Subject: Proposed 2-lot subdivision of SBL 95.4-3-13.210 (99 Peach Lane)

Subject: Response to public comment and letter by Ms. Maria Stavroulakis residing at 73 Peach Lane

2-LOT SUBDIVISION FOR:
NASON
S.B.L.: 95.4-3-13.210 / 99 PEACH LANE / 23.38 ACRES
TOWN OF MARLBOROUGH, ULSTER COUNTY, NY

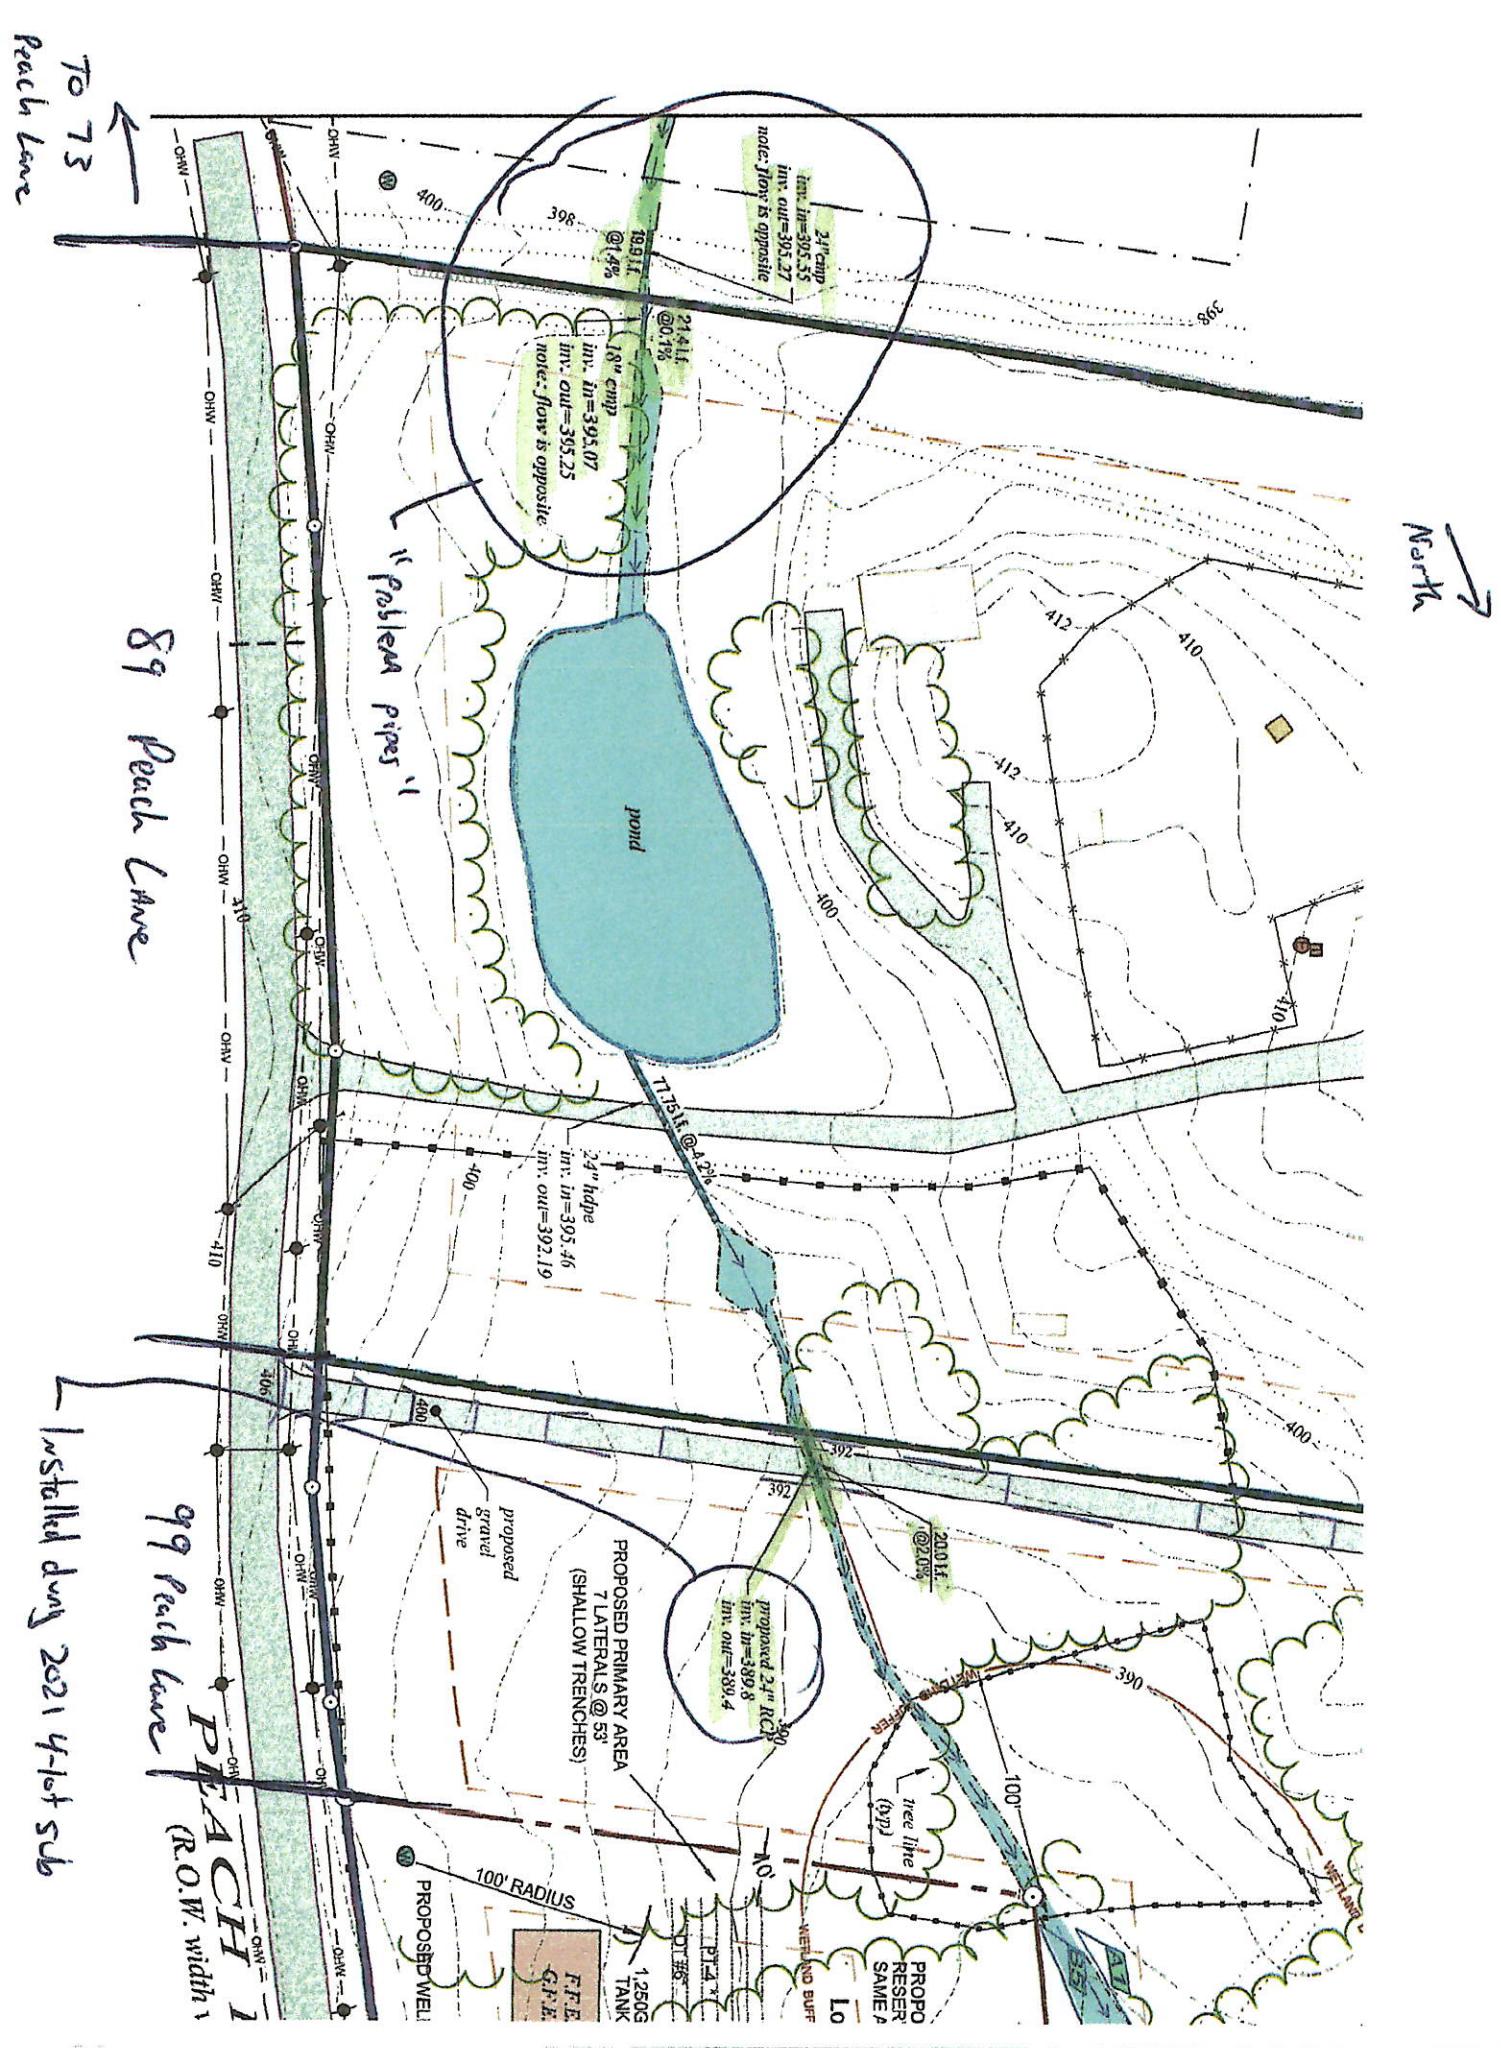
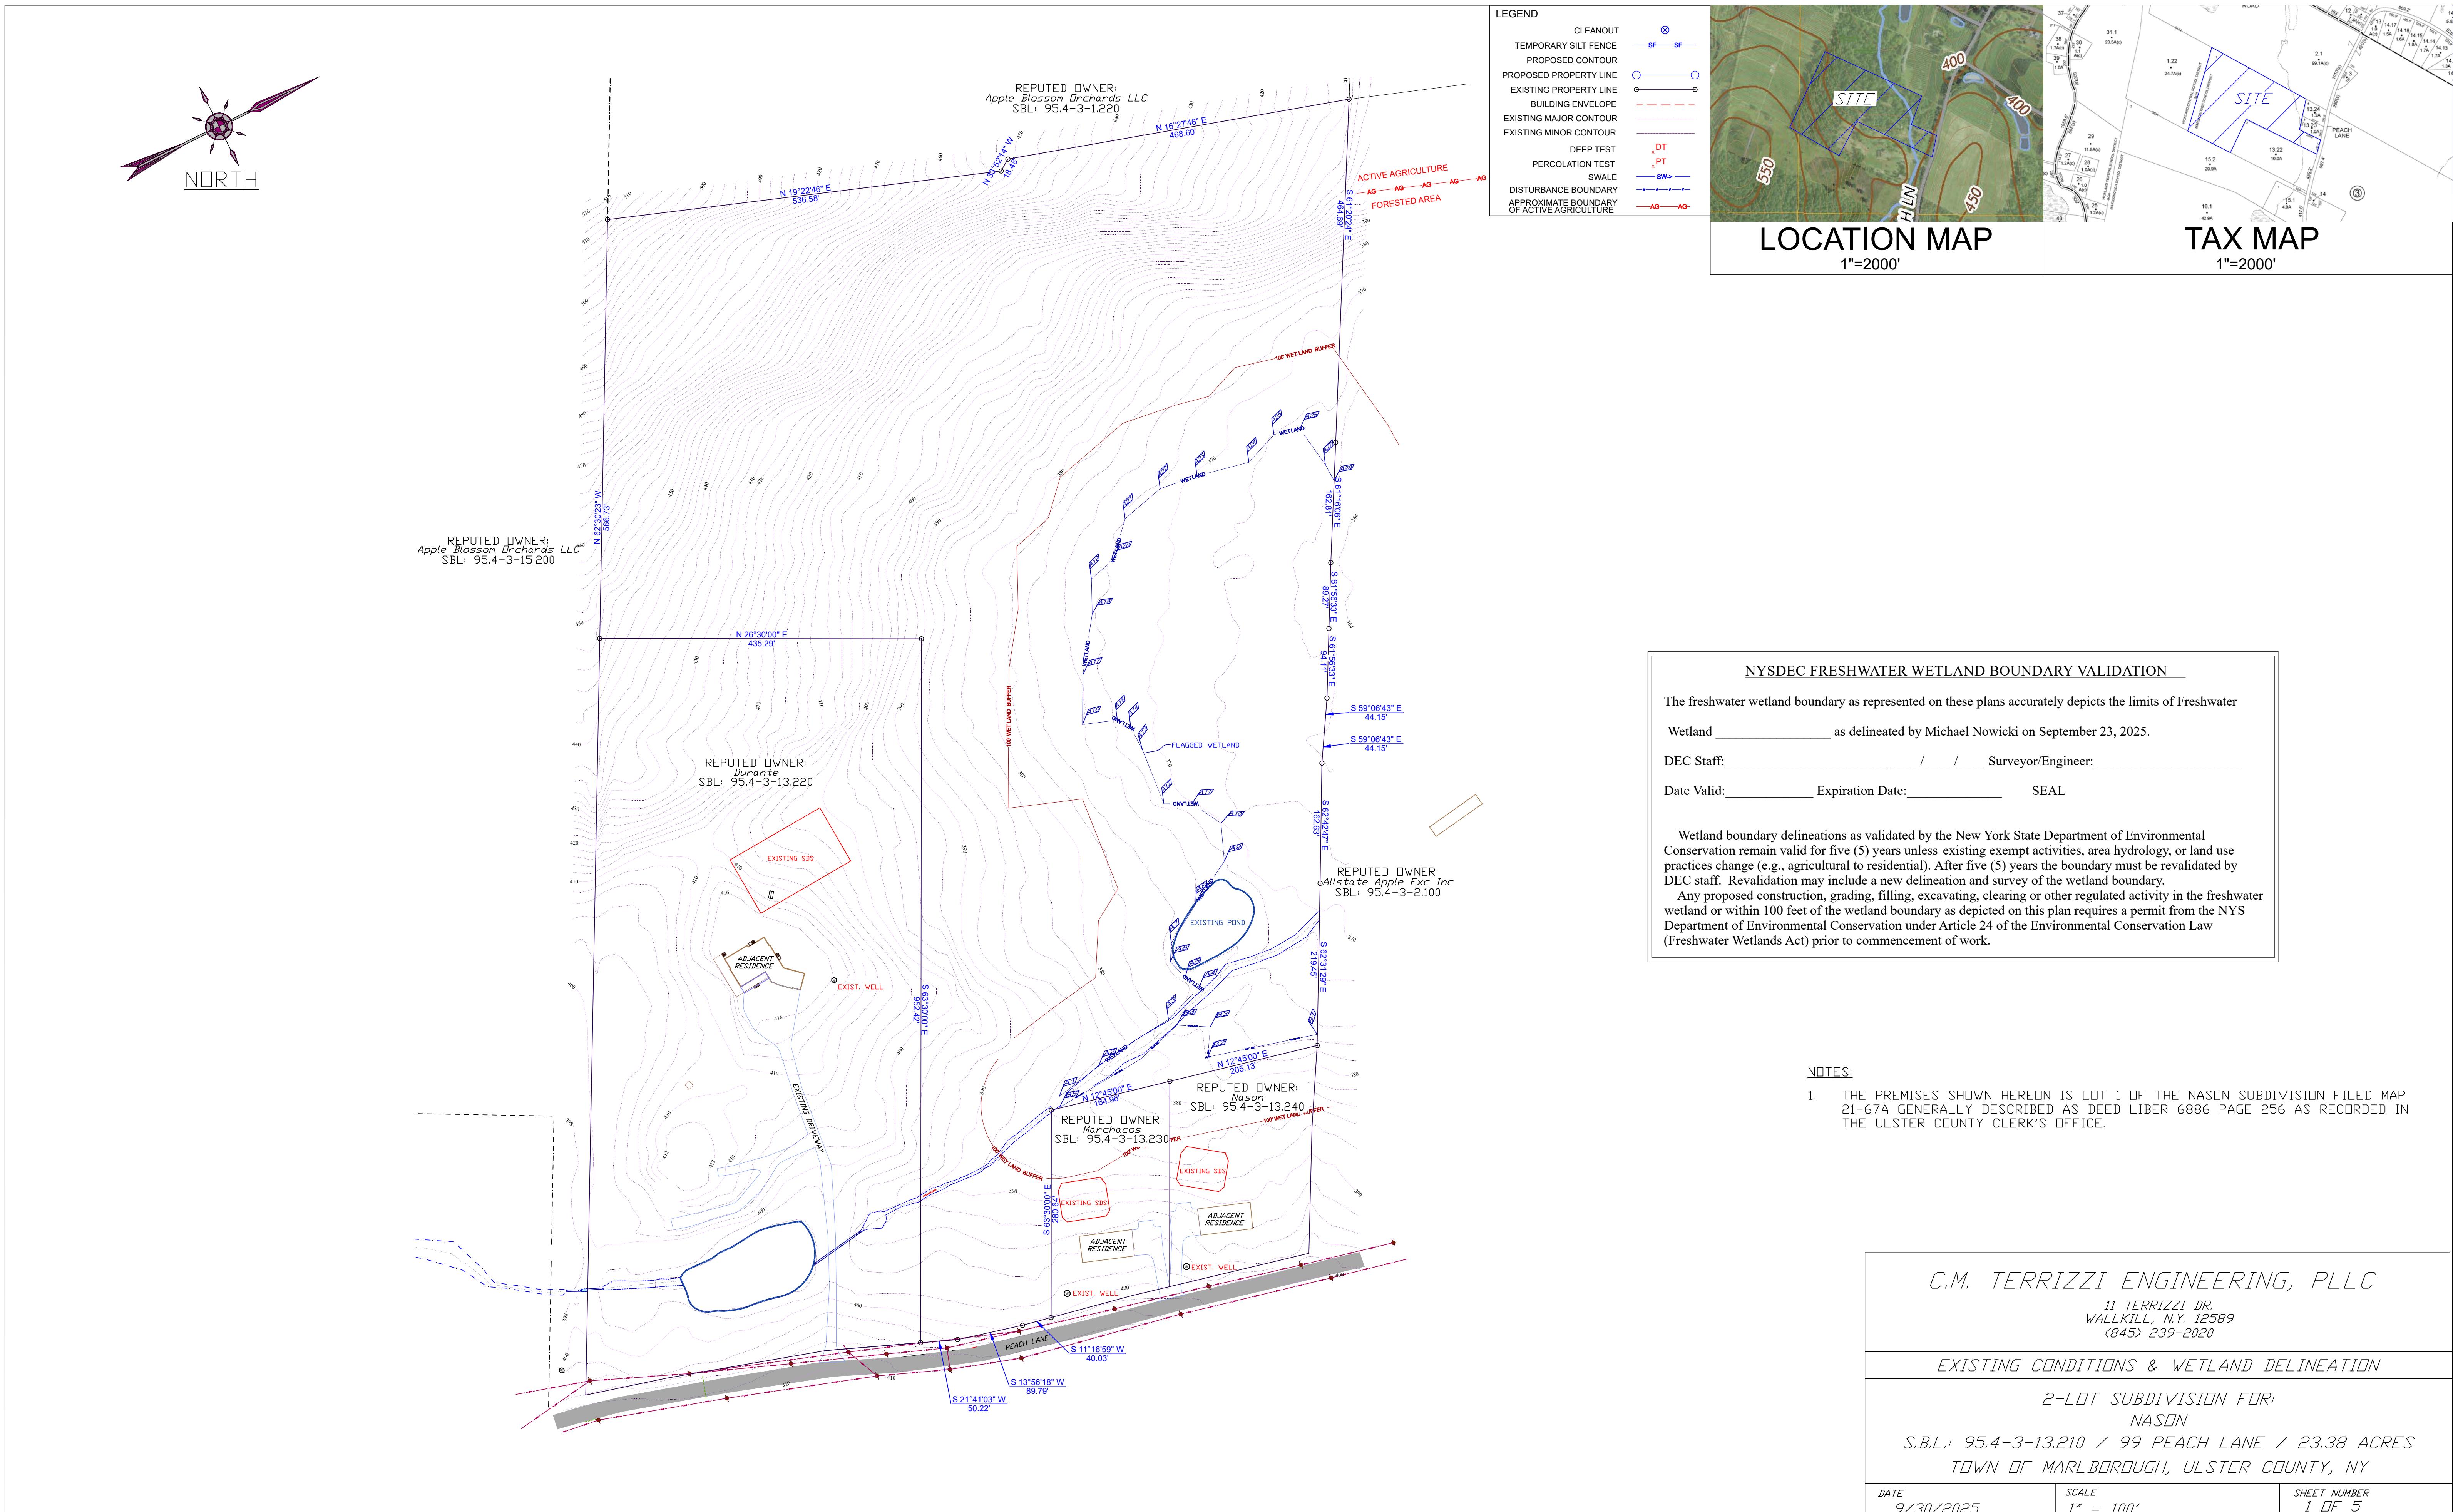
I am in receipt of a flooding concern brought to light by Ms. Stavroulakis at 73 Peach lane.

I have evaluated the area of concern and have concluded that the drainage issue experienced on her property is likely due to an existing undersized pipe as she suggests or an existing pipe grade opposite the natural flow of the watercourse.

In either case, the pipes are situated on the parcel at 89 Peach lane and were present prior to Ms. Nason's 4-lot subdivision approved in 2021. Only one pipe (the 20lf 24" pipe under the driveway of Lot 1) was installed as part of that subdivision and was done so in accordance with the line and grade indicated on subdivision plans.

The problem pipes Ms. Stavroulakis refers to are upstream of the proposed Nason 2-lot subdivision at 99 Peach lane currently before the planning board.
